Morlais Project

Terrestrial Ecology Assessment Update

Document Reference: MMC189 MOR-RHDHV-DOC-0110

Updated assessments for terrestrial ecology (excluding chough) in response to comments made on the Environmental Statement by NRW and RSPB – version 03

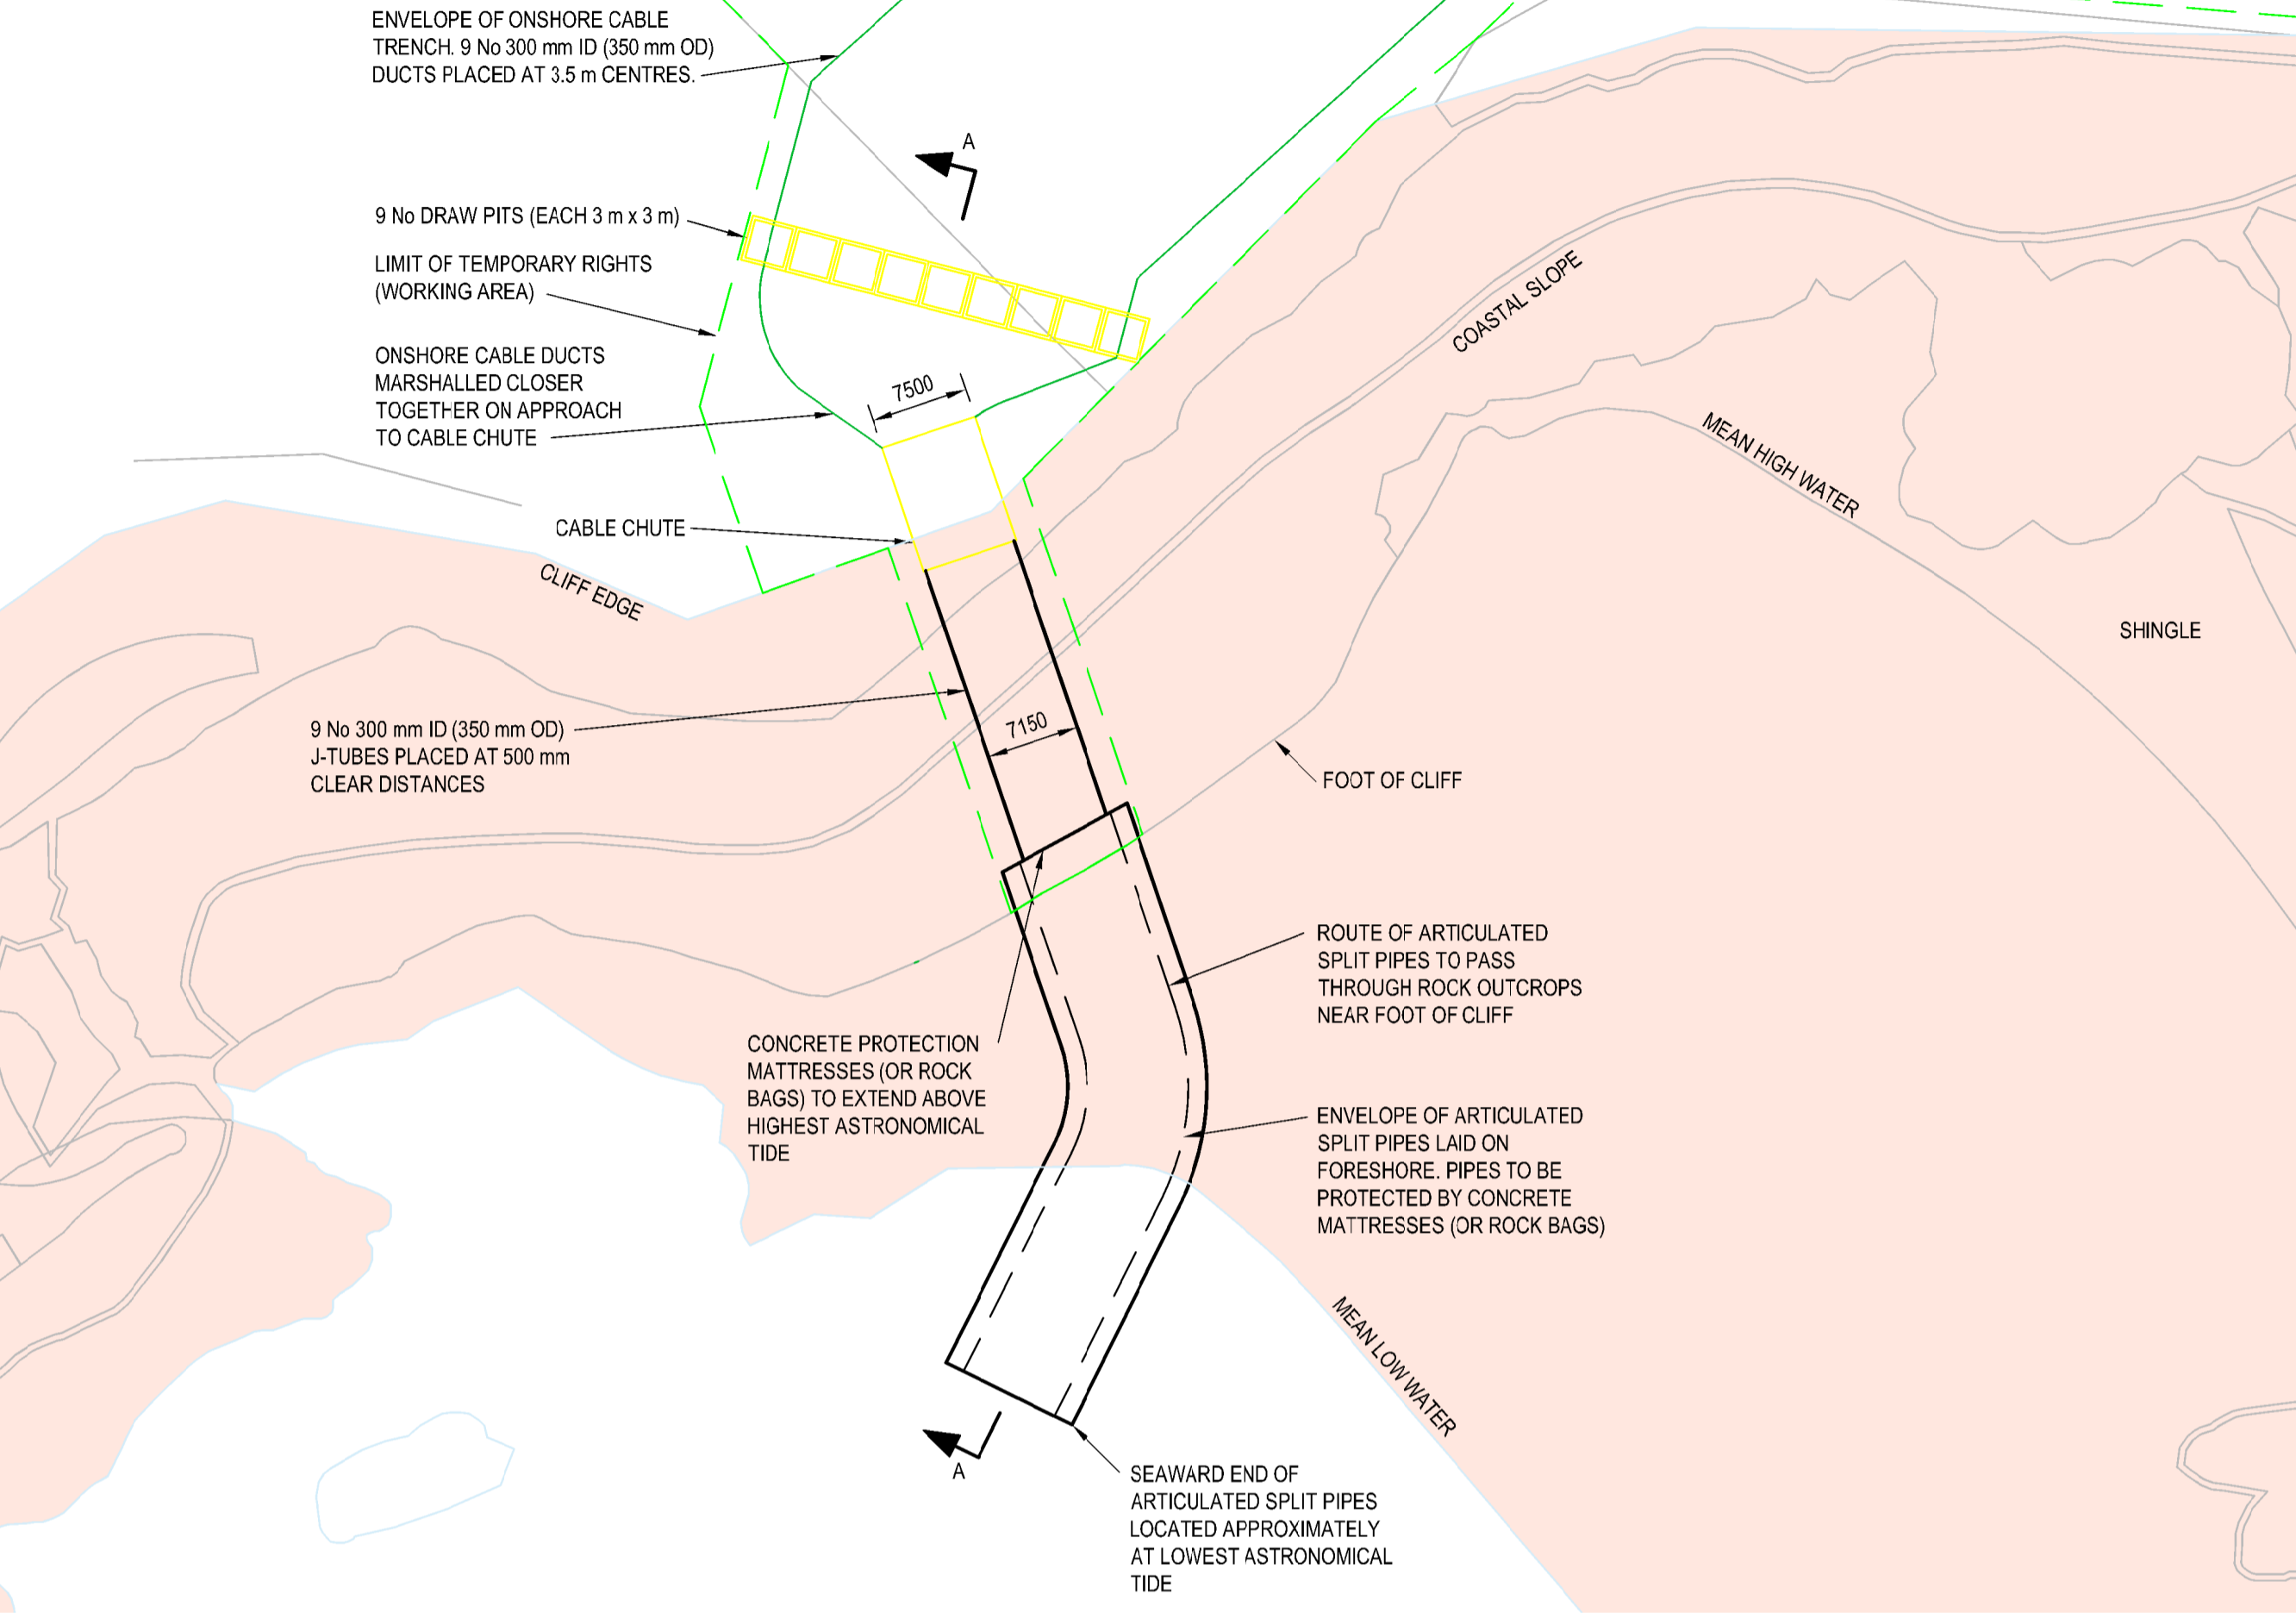
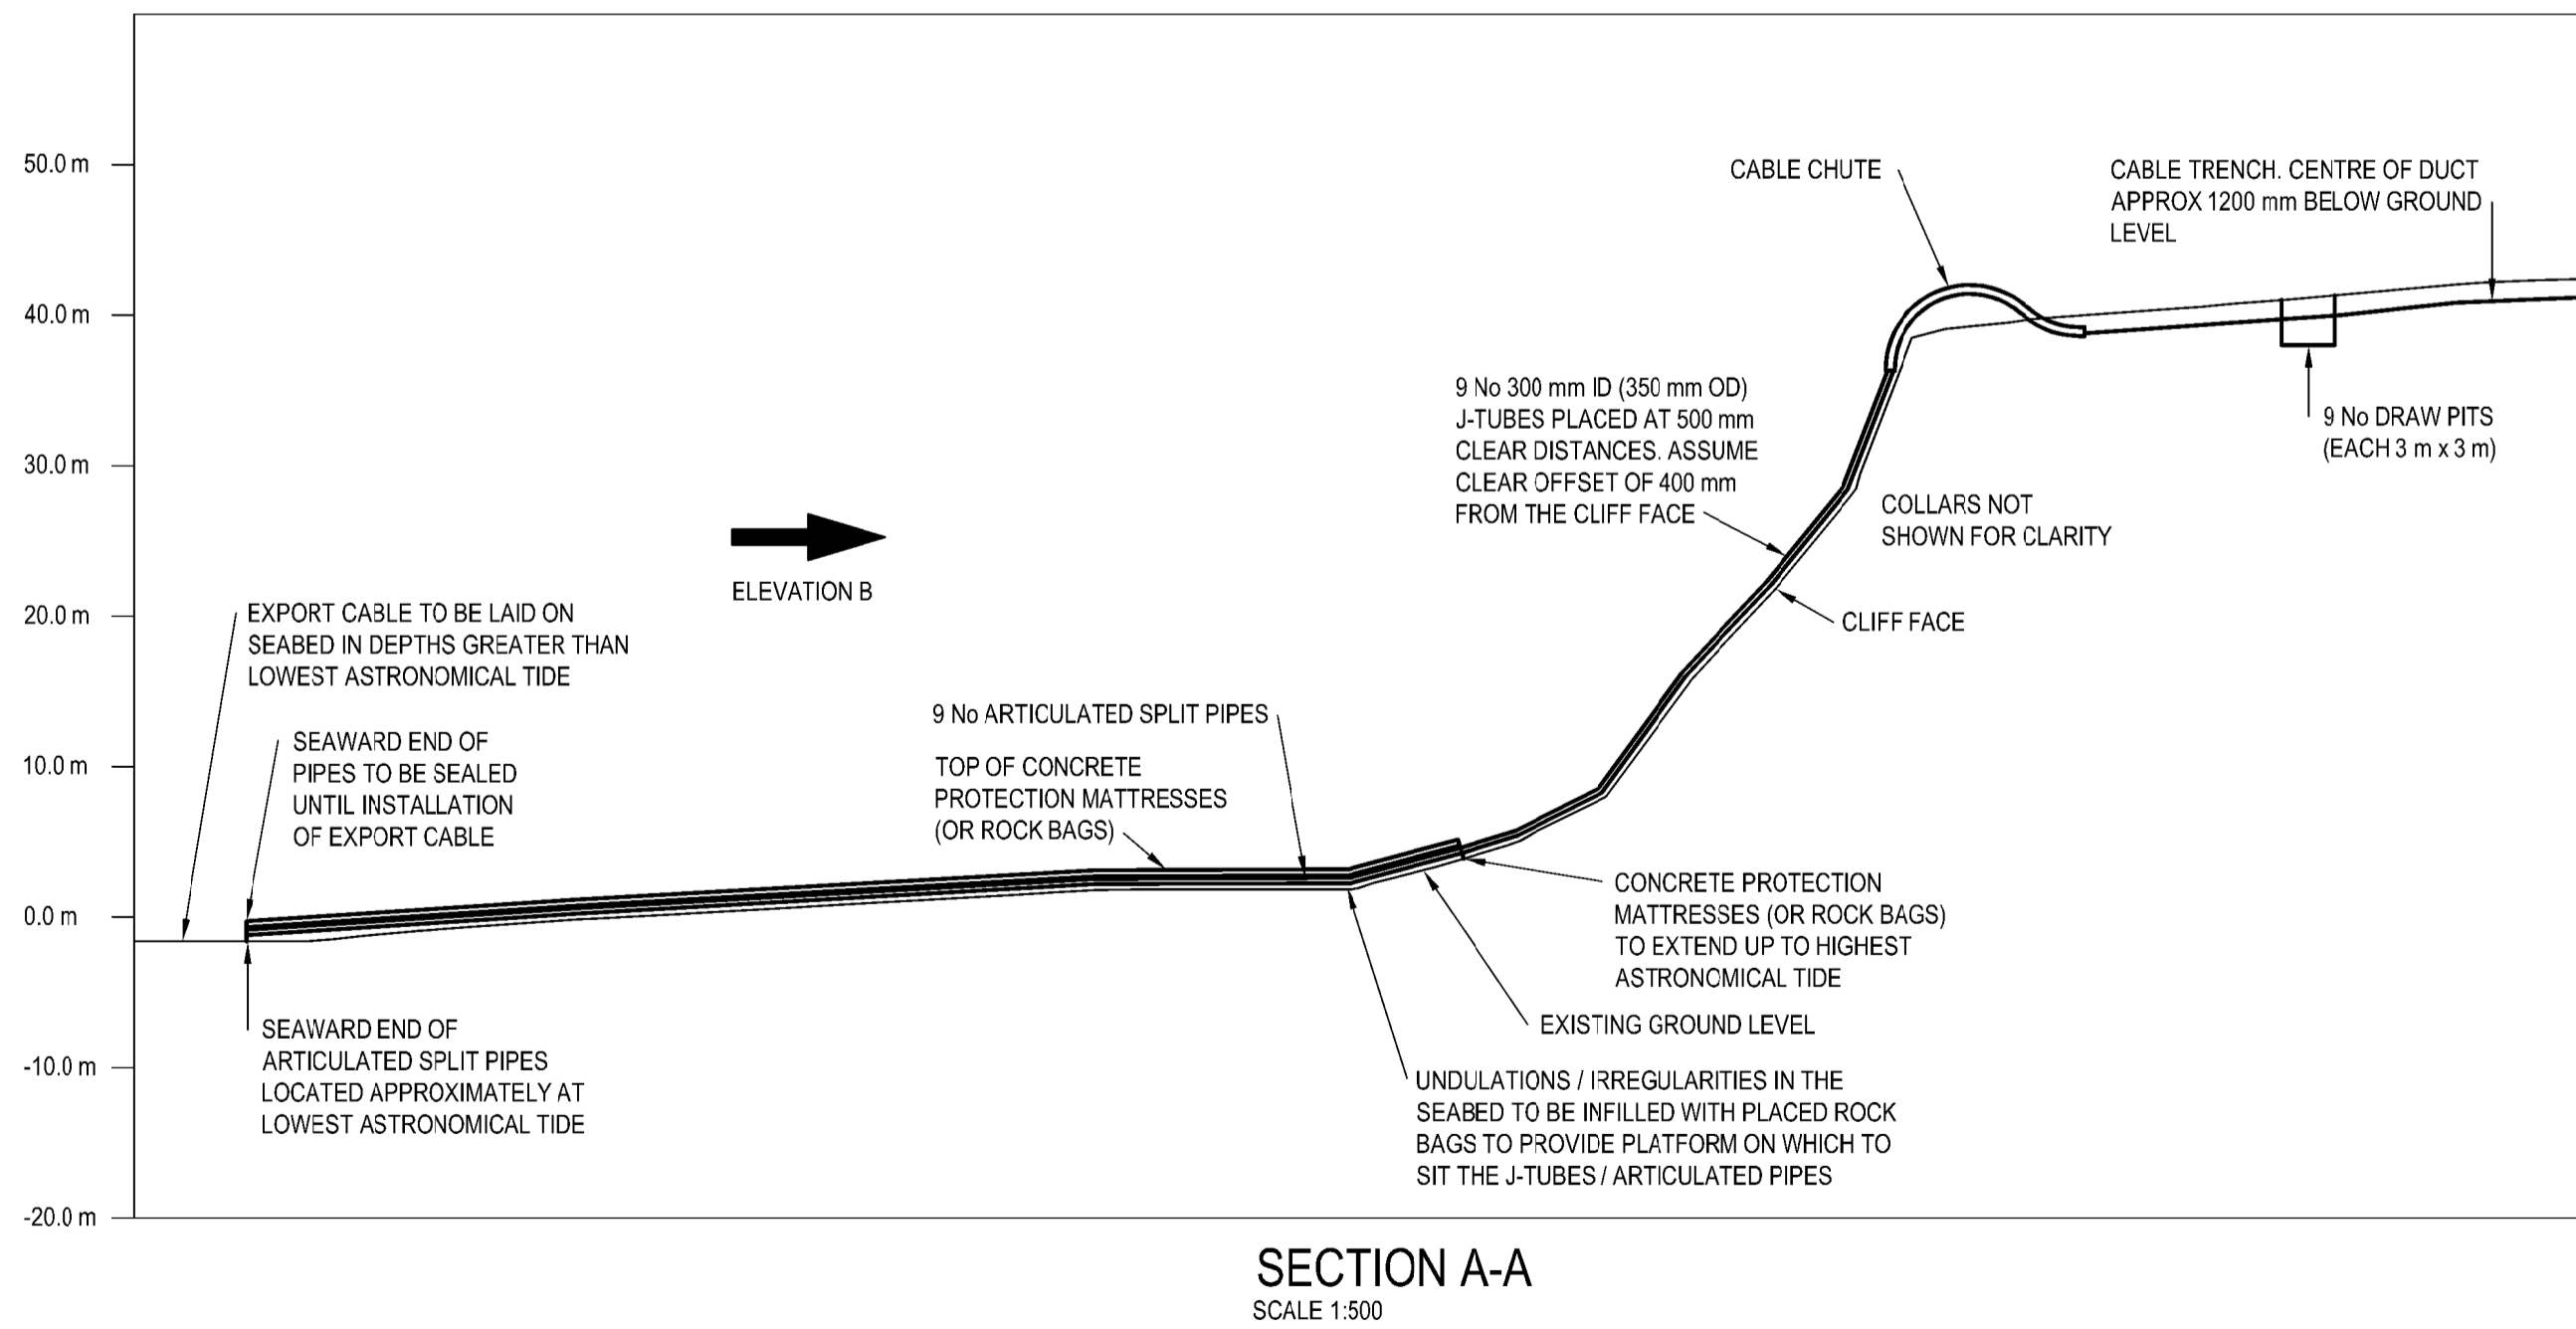
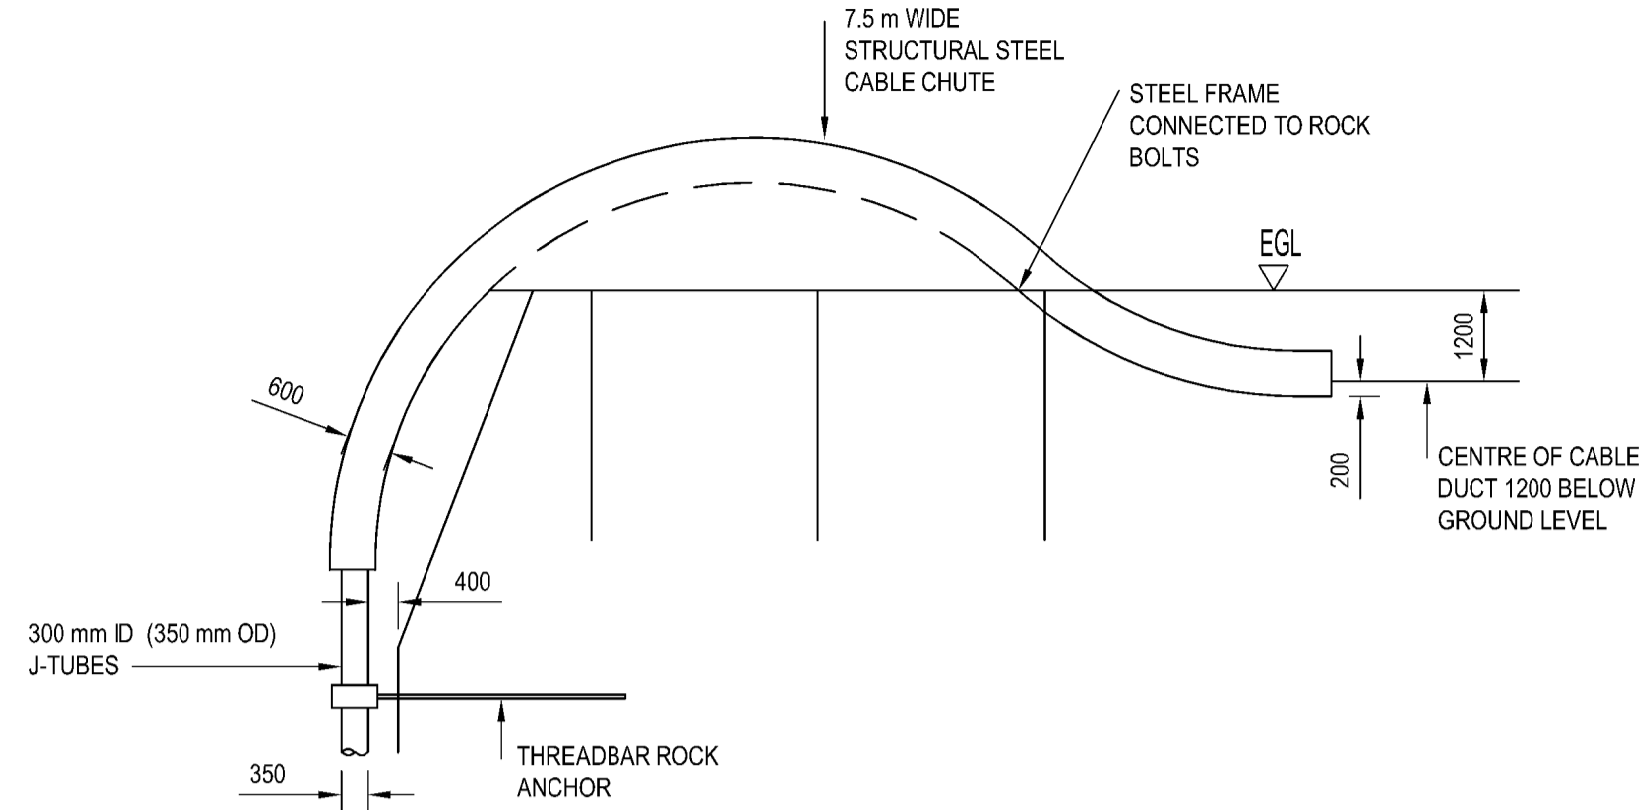
Comment Number	Comment Detail	Morlais Response
2	Drawing 2: Concrete apron at toe of cliff – up to Highest Astronomical Tide. There is a need to assess whether any qualifying SSSI features are present in this area: rockpools, caves and overhangs under boulders	These features do not appear on the citation for the SSSI https://naturalresources.wales/media/656113/SSSI_0963_Citation_EN001c75d.pdf
3	Drawing 2 shows the wrong SSSI boundary at the north-west end of the area where cables come ashore. It should follow mean low water but at c SH215815 the low water mark disappears and only the high water boundary is left.	Drawing 2 has been amended to better define the SAC boundary
4	The areas shown for stockpiles still seem quite small relative to the volumes of material to be stored, even allowing for opening trenches in short sections. Turf storage usually requires a lot of space.	For the construction phase of the project, a detailed Materials Management Plan will be developed by the contractor and submitted for acceptance by the client. All construction works will be programmed and undertaken to meet any planning and environmental constraints that are imposed on the works. It is however anticipated that the works will be phased to minimise environmental impact and disruption to local receptors. Construction of the works will be phased to suit available land take (e.g. stockpile and laydown areas) which will accommodate the temporary storage of turf as required. (See Section 5).
